Imation Corp.

Reply to FCC ID: PB4-TDKA28

We, Imation Corp., state that our device, FCC ID: PB4-TDKA28, modified PCB as follow, only change the white earth cable into PCB printed cable. Spurious emissions is retested, and the result is shown in test report page 16-18. This application is for Class II permissive change or modification of presently authorized equipment . Please update test report and internal photos documents.

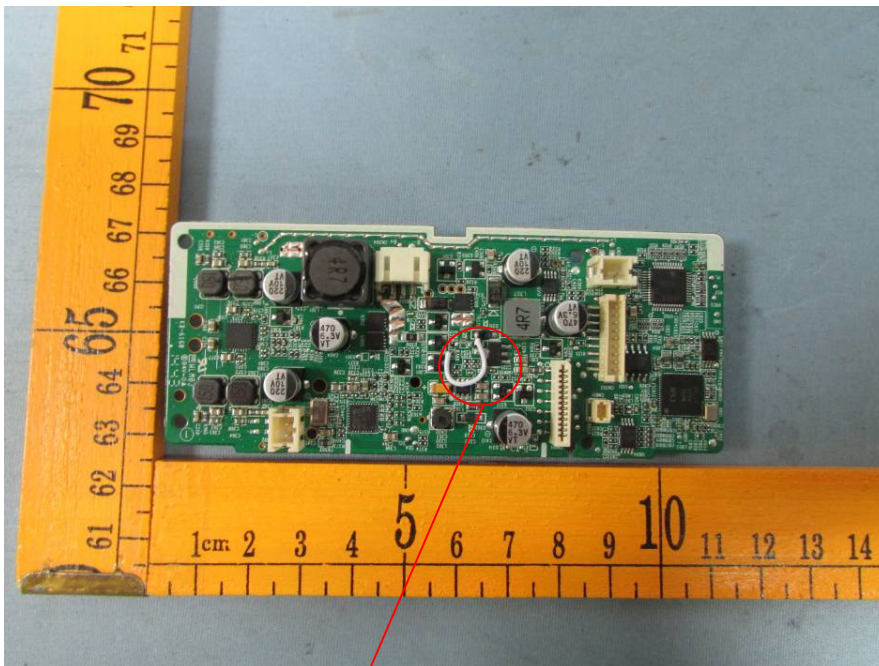
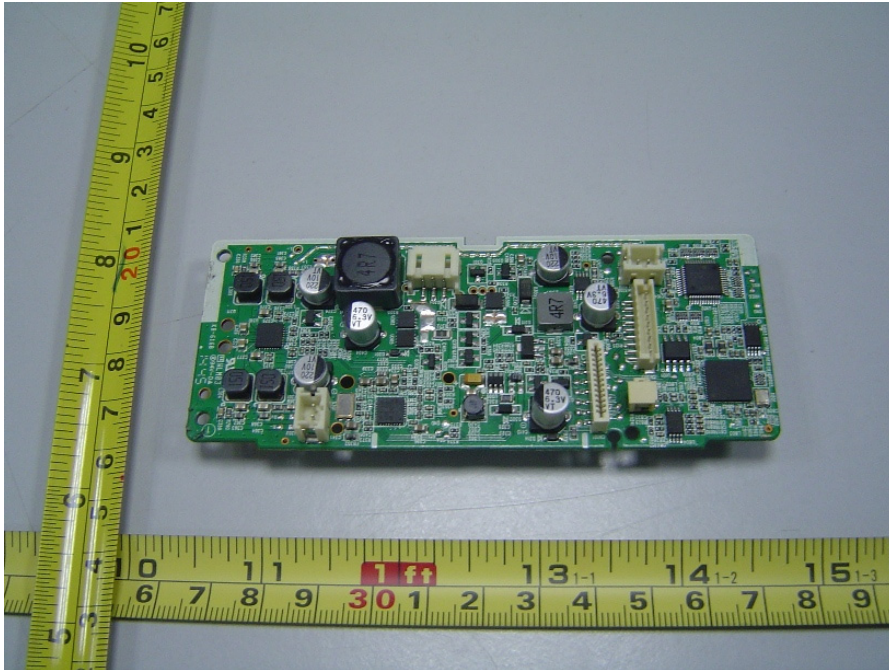
Old PCB

White earth cable

New PCB
